Decommissioning Lake Mokoan Program

ADDENDUM TO REVIEW OF MODIFIED LAKE MOKOAN PROPOSAL

- Final 2
- 12 December 2007

GHD Improvement to Dam Wall

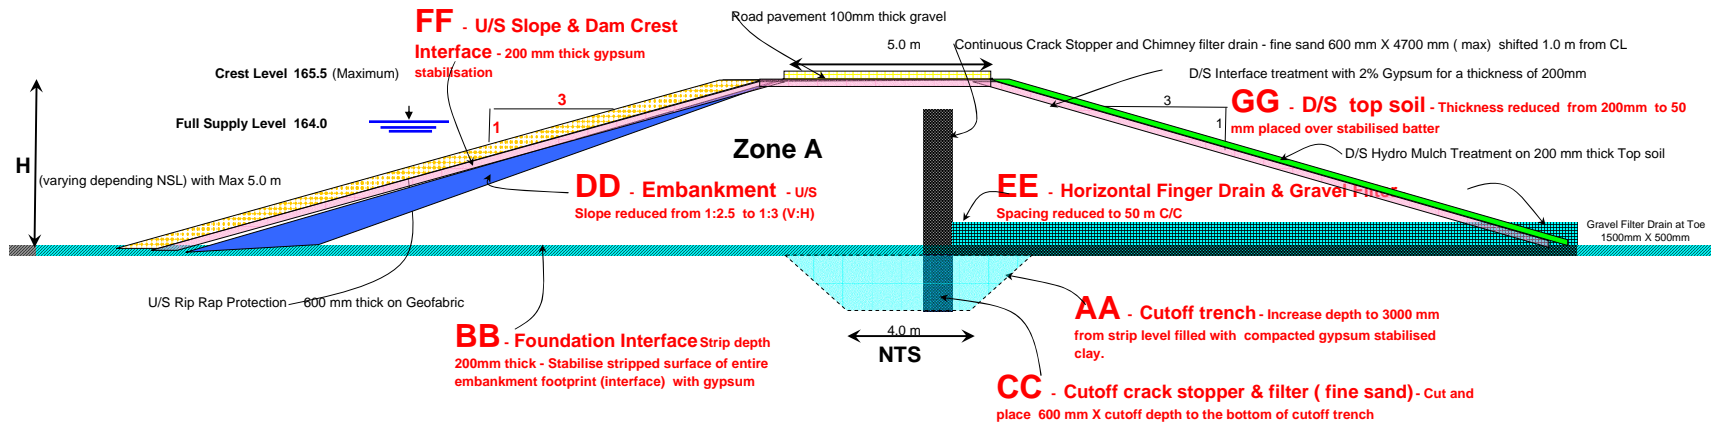
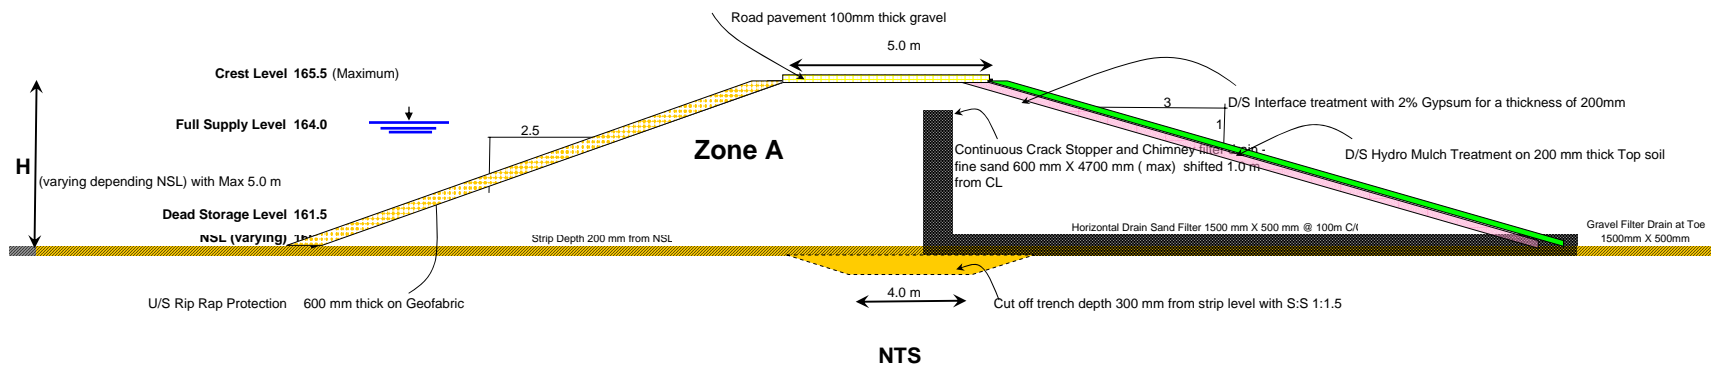
The Modified Lake Mokoan embankment design and the revised proposal (refer Table 1) do not fully address the anticipated geotechnical conditions. There are a number of aspects of this design which are of concern and represent project risk. These design inadequacies are:

- **Depth of stripping** – the depth of stripping of only 200mm, even when combined with the increased cut-off trench depth of 3m, may mean that soft soil layers or layers affected by desiccation cracking could still exist beneath the embankment.

- **Downstream protection** - a provisional 200mm thick layer treated with 2% gypsum. Both the depth of this layer and the percentage of gypsum used (assuming it will be mixed into the soil with agricultural equipment) appear inadequate. The topsoil layer is now proposed as 50mm thick (over the 200mm thick gypsum stabilised layer) and will be treated with fertiliser and hydromulched to revegetate the slope. This revised depth of topsoil is regarded as inadequate and it is not clear from where this material will be sourced. Given this material is unlikely to be available on site, there is a significant transport cost risk for this. It is also noted that this downstream slope treatment will not be adequate for areas where water will be temporarily impounded against the downstream face and protection with rip rap and geofabric to above the water level will be required.

- **Vertical sand filter** – this filter now extends into the foundation in accordance with accepted practice. However, as it does not extend up to crest level, it provides only nominal protection against piping caused by storage levels above FSL permeating either through the embankment or through desiccation cracks above FSL.

- **Horizontal filter drain** - the proposed horizontal sand filter drain, comprising a discontinuous 1.5m wide, 0.5m thick layer at 50m intervals is not considered adequate as it will not prevent piping along the embankment / foundation interface between drain locations. It is noted the foundation interface will now be gypsum stabilised over a depth of 200mm however, as noted above, the adequacy of this measure should be assessed to ensure it is effective in reducing the likelihood of piping.

- **Degree of compaction** - the specified degree of compaction (95% of Standard Maximum Dry Density – (SMDD)) and moisture conditioning at +/- 2% of Optimum Moisture Content, (OMC)) is not considered suitable for dispersive soils as the compaction should be performed at a higher standard (minimum of 97% SMDD) and moisture conditioning must be at OMC or higher (preferably 2-3% over OMC). It is understood that GHD has recommended compaction at 95% and 0 to +2% of OMC and the proponents have not yet accepted this advice. If a lower

MI Original Proposal

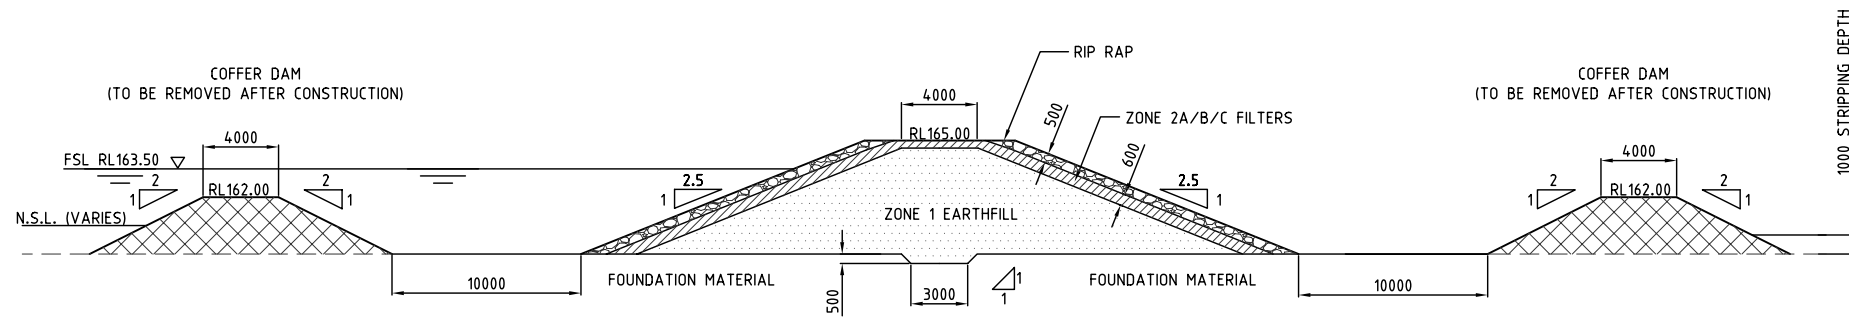
- To address the dispersive soils, the revised proposal now allows for treatment of a 200mm thick layer along the foundation interface and the embankment perimeter (upstream and downstream batters and crest) with gypsum to stabilise the dispersive soils (2% application rate assumed). However, the body of the embankment will remain untreated and the adequacy of the proposed 200mm thick layer (especially if the gypsum is mixed with the soil using agricultural machinery) is unproven.

In summary, whilst the overall embankment geometry is considered satisfactory, the embankment stripping depth and treatment of the dispersive soils (adequacy of the 200mm thick stabilised layer, adopted compaction standards, incomplete filter details) raise concerns regarding the adequacy of the embankment design for the Lake Mokoan site. This relates to piping failure, especially considering the high consequence of failure downstream compared with Barren Box Swamp (which had significantly lower consequence of failure).
